**Correspondence Between  
Staff and Applicant  
Approval Letter**

**Case Reference No: 44-DR-2017 Worldmark By Wyndham**

RE: 44-DR-2017  
Worldmark By Wyndham

The Planning & Development Services Division has completed review of the above referenced development application submitted on 1/9/18. The following **2<sup>nd</sup> Review Comments** represent the review performed by our team, and are intended to provide you with guidance for compliance with city codes, policies, and guidelines related to this application.

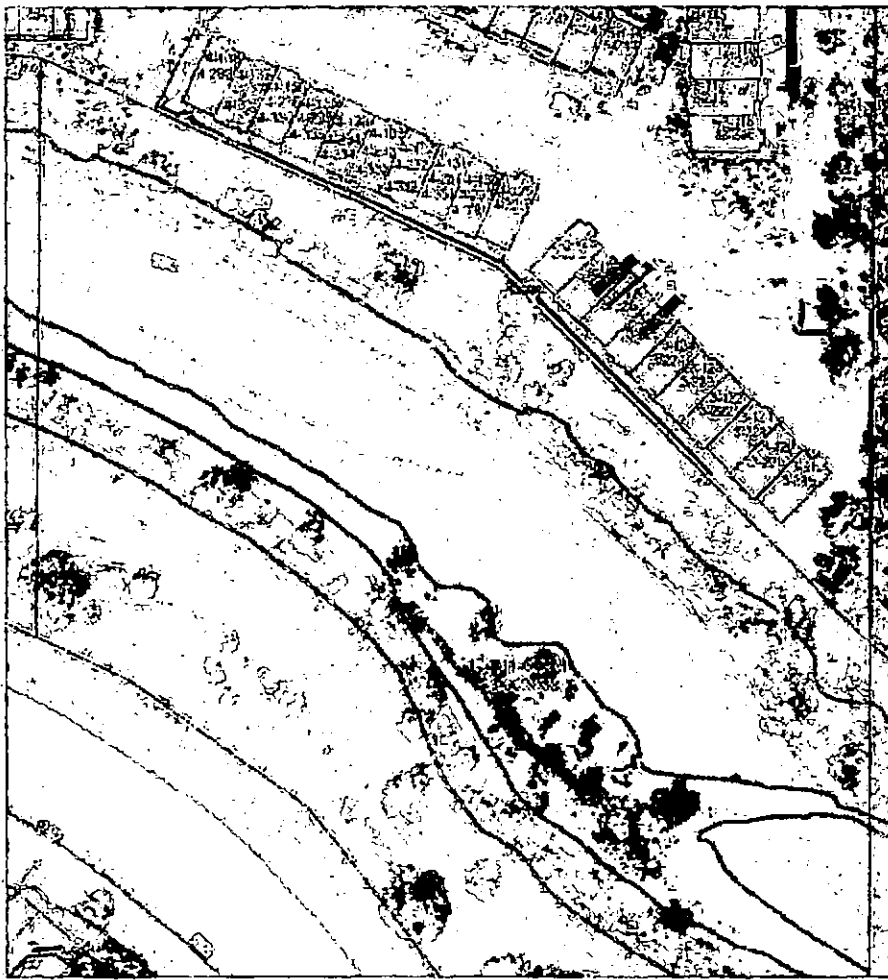
1. A Base Flood Elevation (BFE) has not been established for either of the proposed buildings. The LF<sub>88</sub> of the buildings must meet the current FEMA requirements as well as the current COS Storm Water Ordinance, regardless of what was approved previously. The engineer has called out a 100-year HWE of 1280.83 in the channel on the G&D Plan; however, this information could not be found on any of the supporting documentation included in the report. Please clarify in Section 5 of the drainage report the 100-year HWE elevation.

Additionally, citing the COS quarter section topographic maps (dating back to 2005) as the basis for establishing the LF<sub>88</sub> is not acceptable. As indicated in the following graphic from the City's LIS system, which show the 2010 FCDMC 2.0-foot contours based on the flown LiDAR data for the Lower Indian Bend Wash ADMS, the north bank of the channel (along the narrow X zone strip) can be as high as 1283.5; which may be the defining elevation for the BFE.
